LINCOLN CITY/LANCASTER COUNTY PLANNING STAFF REPORT

P.A.S.: Change of Zone #3386 **DATE:** December 19, 2002
Preliminary Plat #02022 - G&C Addition

PP#02022 - Creates 15 lots for development and one outlot for storm water detention.

To: Brian Will, Planning Department
From:  Chad Blahak, Public Works and Utilities
 Dennis Bartels, Public Works and Utilities
Subject: G & C Addition Preliminary Plat

G & C ADDITION PRELIMINARY PLAT

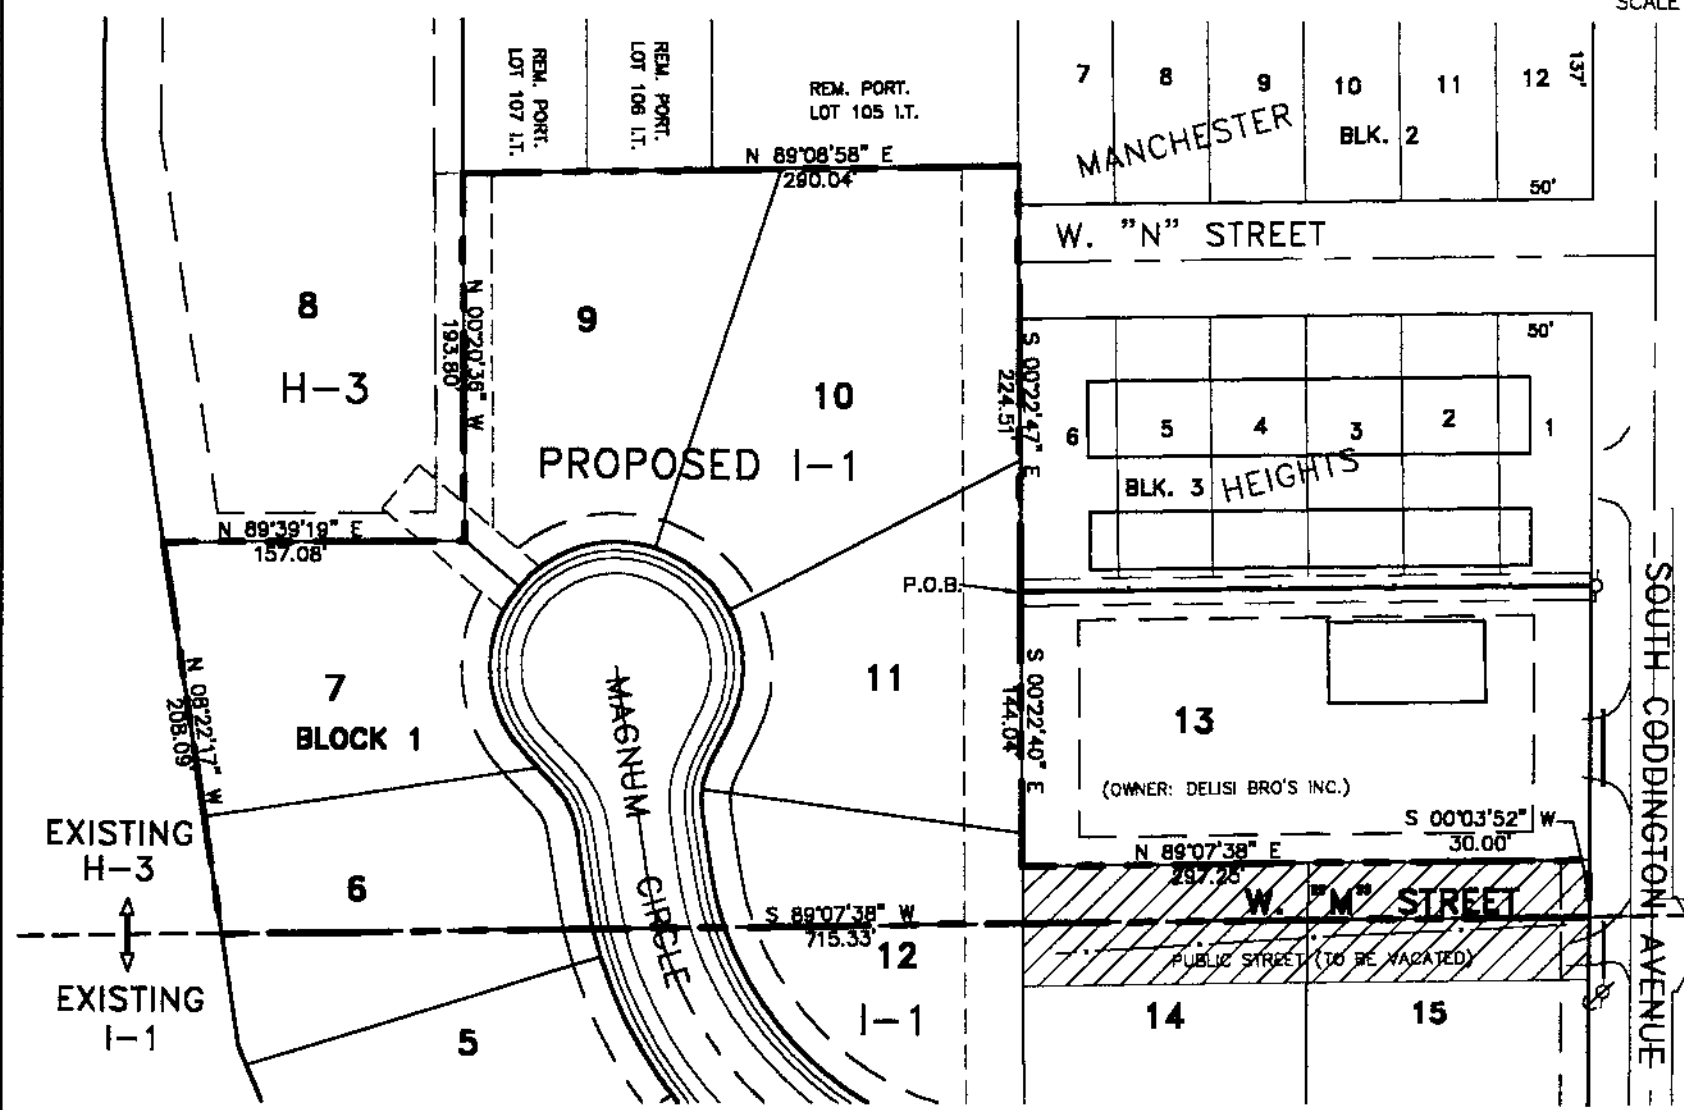
- 1.1 Revise the preliminary plat to show:
 - 1.1.1 Required paving, curb and gutter, sidewalks and street trees along that portion of the plat adjacent to South Coddington Avenue.

- 1.1.2 Revise Note #26 to read as follows:
The following waivers to design standards for subdivisions are granted:
A. To allow Outlot A without frontage to a street.

- 1.1.3 Add Note #28 stating that final plats will not be approved until West M and N Streets west of South Coddington Avenue have been vacated.
 - 1.1.4 Revise the landscape plan to show required street trees along South Coddington Avenue.

- 1.1.5 Revise the legal description to include a portion of the vacated alley through Block 3, Manchester Heights Addition.
 - 1.2 The applicant submits a revised grading and drainage plan for review and approval by Public Works and Utilities.

The south side of the proposed detention cell top of bank width is less than the minimum 14' required by city design standards. The grading should be revised accordingly maintaining required storage capacity.

What channels are to conform to the proposed channel detail? Contours should be shown on plan to indicate where engineered channels are located. Also, include in the detail the 100 year flow elevations.

The grading on the east side of Lots 10, 11, and 12 show the channel outside of the drainage easement. Show that the channel inside the drainage easement is sufficient to accommodate the design storm.

5. Requested Waivers - Coddington Avenue paving from O Street south to the south limits of this plat is a rural cross-section street with open ditches. This paving is substandard to meet subdivision regulations. Engineering Services recommends that no waivers be approved. If the street is paved per standards, sidewalks can be built so the request to waive sidewalks is also recommended for denial.
